ERCOT Batch Load Study Process Withdrawal Risks

3/23/2026

CCR's Concern

Batch Study: Post-IA Commitment / Refinement Study

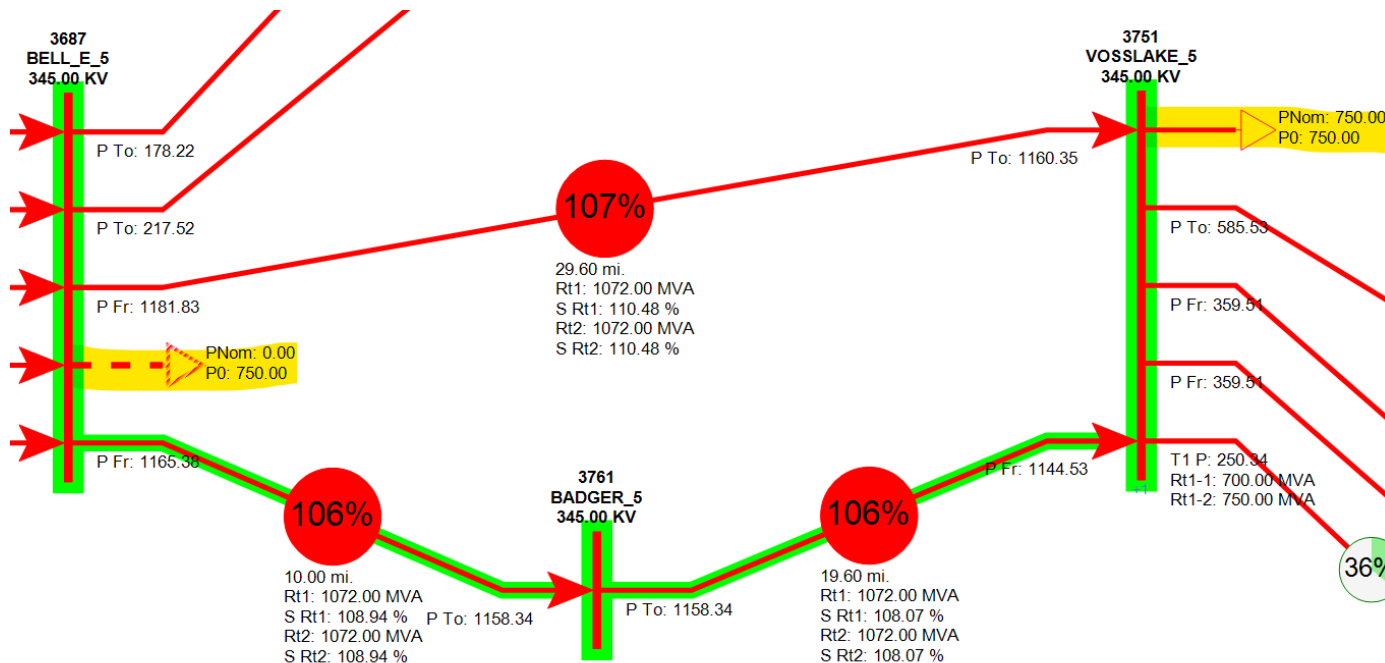
- New overload caused by Load A dropping

- ERCOT can no longer guarantee 750 MW for Load B in 2028, as a network upgrade is now required.
- Assuming a 3-year upgrade timeline, the LCP will need to be updated.
- Load B executed an IA based on the assumption that 750 MW would be available in 2028, which is no longer feasible.

Reduced Voss Lake 345 kV Load Serving Capacity: 375 MW

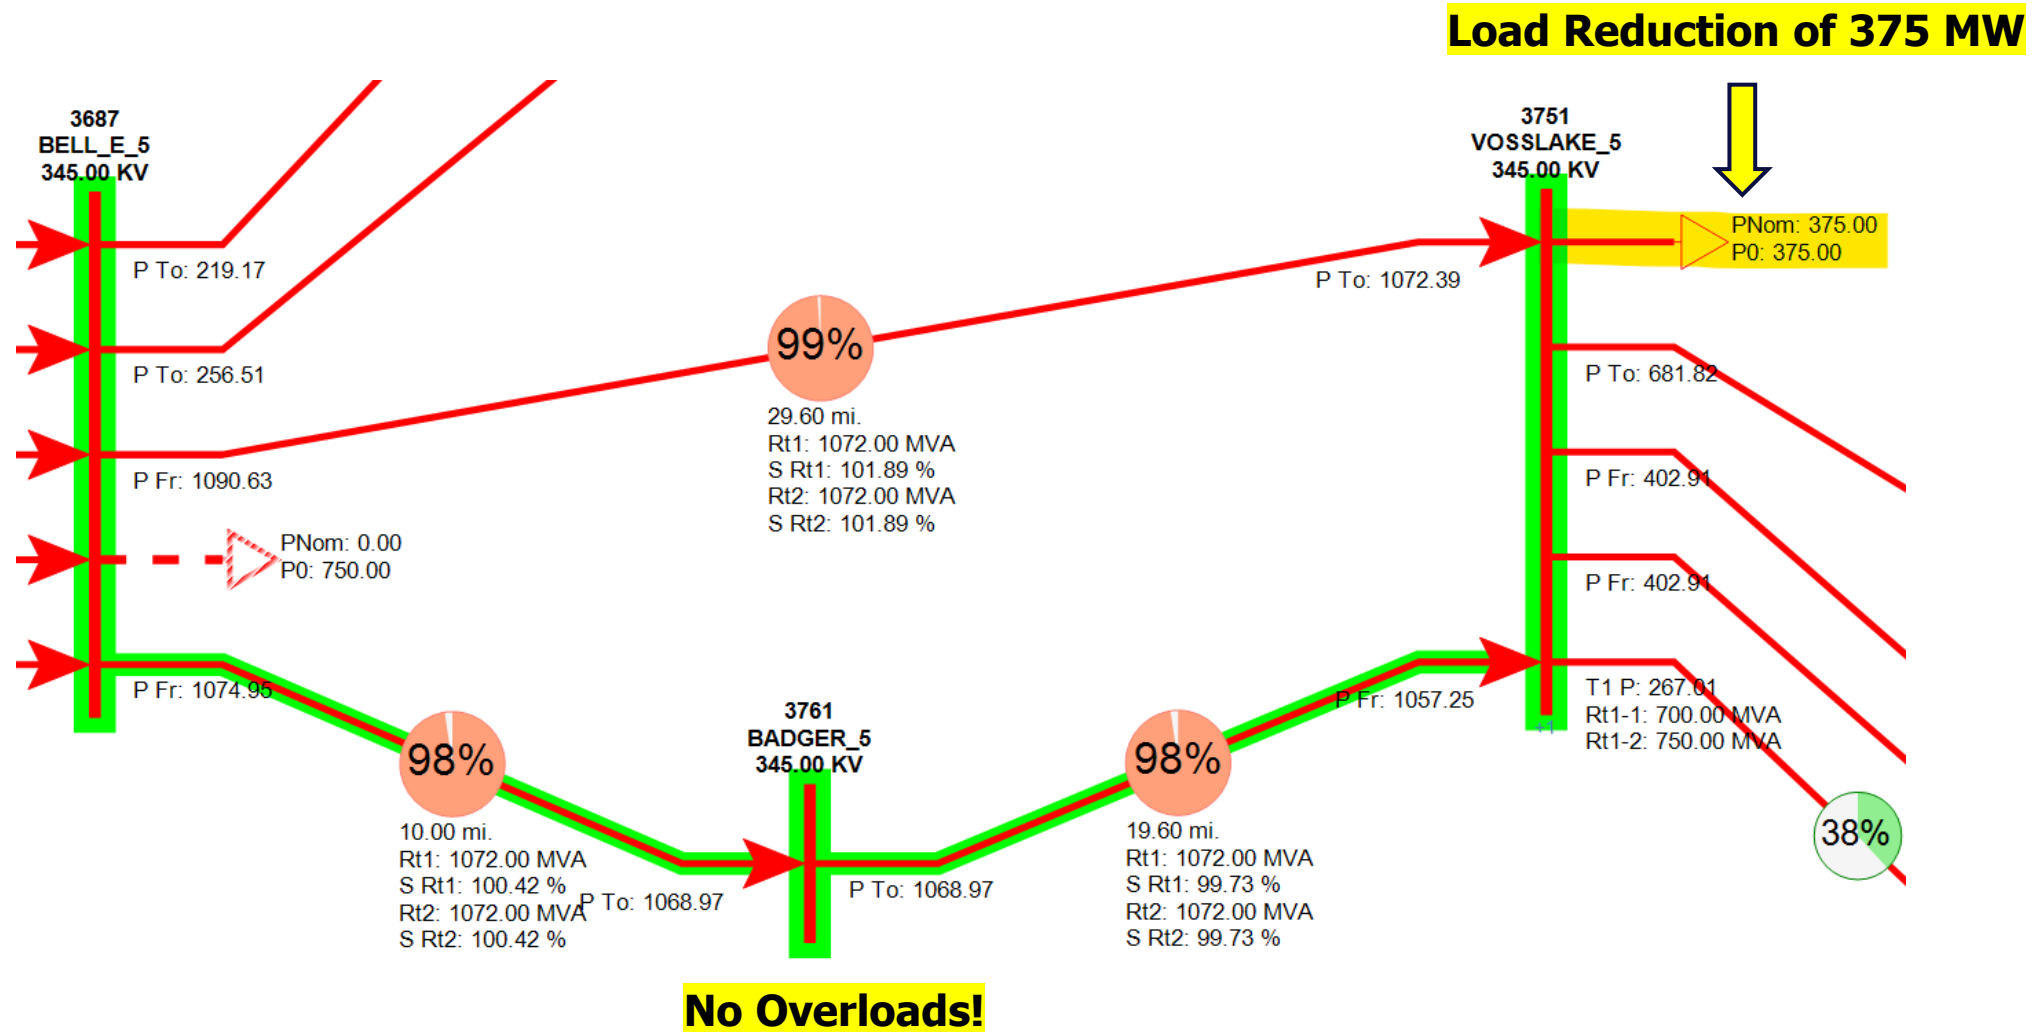
- In this scenario, Voss Lake 345 kV load would need to be reduced significantly to mitigate the new overload introduced by withdrawal of the Bell E 345 kV load

- Will ERCOT Refinement identify new upgrades needed to solve reliability violations that occur after LL drop? If so, who will bear the cost of those new upgrades that were not part of the original Batch?

- Will ERCOT update LCP after refinement period identifies new network upgrades?
